INDESIT company

Model type:
WE14SDE

Commercial code:
F027150

Fig. n10402231

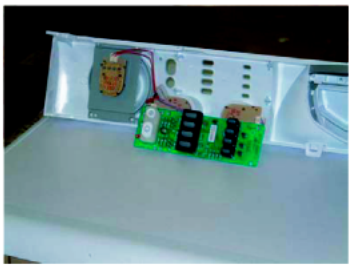
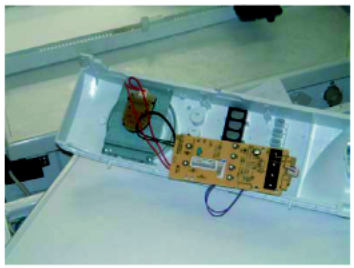
n1040231: Absent upper counter-weight

Our dishwashing machines have been designed with a static and dynamic balancing system to conform with the vibration, noise level, stability and reliability specifications.

In particular, the balancing has been obtained by the "balancing" mass, appropriately placed on the oscillating group. This balancing mass is made for:

Machines with spin cycle speed lower than 1400 rpm, by a frontal and an upper counter-weight in reinforced cement;

Machines with spin cycle speed equal or faster than 1400 rpm, by a frontal counter-weight in reinforced cement and by a cast iron universal joint spider (a red cross shaped component with 4 spokes, that in this range of washing machines fulfils both the structural and balancing functions);

FIG. 1

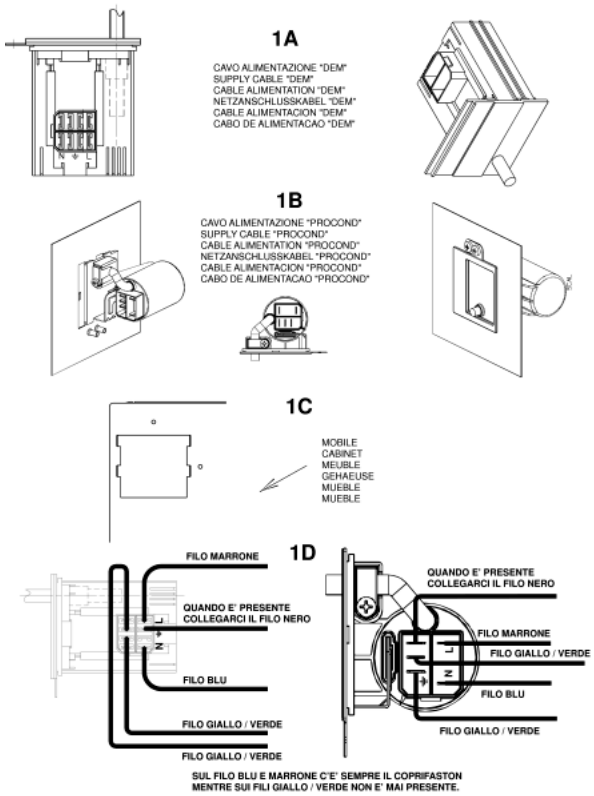
n1040276: Power supply cable + integrally moulded filter.

All appliances produced in the Comunanza (from serial no. 21008.0001), Teverola (from serial no. 21111.0001) and Brembate

(from serial no. 21119.0001) factories have been equipped with power supply cables with integrally moulded filter (see fig.1 - 1A and 1B) and new units having a specific opening at the back for fixing the new cables (see fig. 1 - 1C).
The new units, together with the new cables, can be used in place of the premodification ones, by connecting the wiring to the cable, as shown in figure 1 - 1D.
The codes of the new units and of those replaced (ESI - table n1040276fig02), which will be managed until stocks run out, are given below.

IMPORTANT: the fixing / continuity screw is a specific self-scraping screw (code 092348) that ensures earth continuity between the filter and the unit. The same screw must be refitted in order to guarantee machine conformity.

The premodification wirings, are also managed for modified products by making the connection to the terminal block of the new cable as shown in fig. 1 - 1D.
The wiring diagrams given in the Documentation remain unchanged.

The new power supply cables are:
Code 091632 - Power supply cable 3x1 schuko 1.5m+capacitance filter;
Code 091633 - Power supply cable 3x1 schuko 1.5m+inductive filter;
Code 091634 - Power supply cable UK 3x1 l= 1950mm + inductive filter;
Code 091635 - Power supply cable UK 3x1 l=1950mm+capacitance filter;
Code 091636 - Power supply cable l=2.55m AUS+inductive filter;
Code 091641 - Power supply cable l=2550mm AG +capacitance filter;
Code 091642 - Power supply cable 1.85mt SHUKO no inductive filter;
Code 091643 - Power supply cable 3x1 (CH) 1.5m+inductive filter;
Code 091645 - Power supply cable 3450mm SOUTH AF.+capacitance filter;
Code 091690 - Power supply cable shuko l2.55m KOREA+inductive filter;
Code 091689 - Power Supply cable l=2550mm AG+inductive filter.

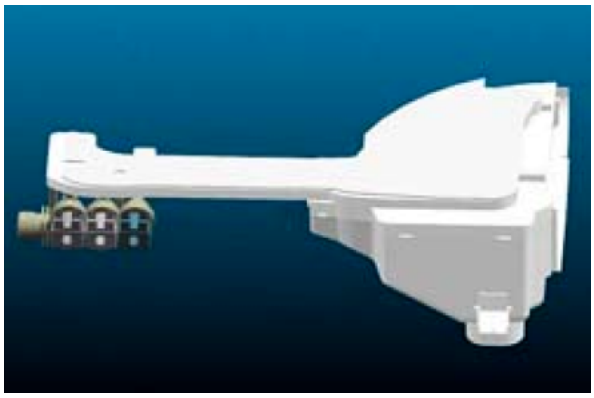
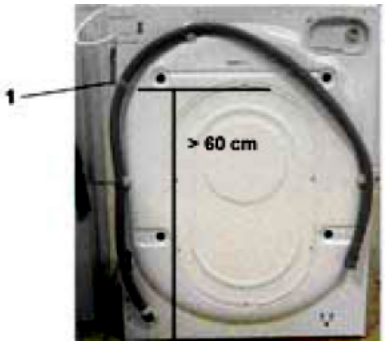
n1040282: New drainage OKO system.

From serial number 21219.0001, the new "OKO" drainage system has been introduced on the washing machines produced in the Comunanza factory.

The new items are:

- EEPROM (the OKO system requires a new setting of load timing parameters). THE NEW EEPROMS REPLACE ALL THE ONES CODED PREVIOUSLY.
- BOWL (hopper tube hole shifted forwards);
- DETERGENT LOADING TUBE (see fig. 1);
- PRESSURE SWITCH (changed levels);
- OKO PUMP BOWL BLOWER + BALL (see fig. 2A, 2B and 2C);
- CONDUCTIVITY SENSOR (if provided, it is shorter than the premodification item);
- DRAIN PUMP (without detergent collecting tube connection);
- HOPPER (shifted in front of detergent loading tube connection). Fig. 3A post-modification. Fig. 3B premodification);
- AIR TRAP (different shape);
- PRESSURE SWITCH TUBE (different length);
- DRAIN TUBE STOP (specific);

In particular, the OKO system consists of a spherical plastic component inserted in the tube that connects the bowl to the drain pump (see fig.2 A).
At the beginning of each wash cycle the washing machine fills water for 10 seconds and activates the drain pump for 2 seconds. In this way, the water level in the bowl is different from that in the drain tube; this difference increases the thrust of the ball upwards, closing the bowl-pump connection tube hermetically (see fig. 2D).
This system has the double advantage of:

1) separating the wash water and the water in the drain hose, thus saving energy during the heating phase;
2) and ensuring optimal use of all the detergent.
With the introduction of this new component, the detergent collecting tube is no longer required and the pump has one hole only to convey water from the tank.
For the correct operation of the OKO system, it is important that the drain hose of the washing machine remains fixed to the back of the unit with a plastic clamp (to this end, the clamp withstands a 25 kg load; see reference 1 in fig. 4); otherwise, the drain hose must absolutely reach the height of the clamp. (minimum 60 cm.)
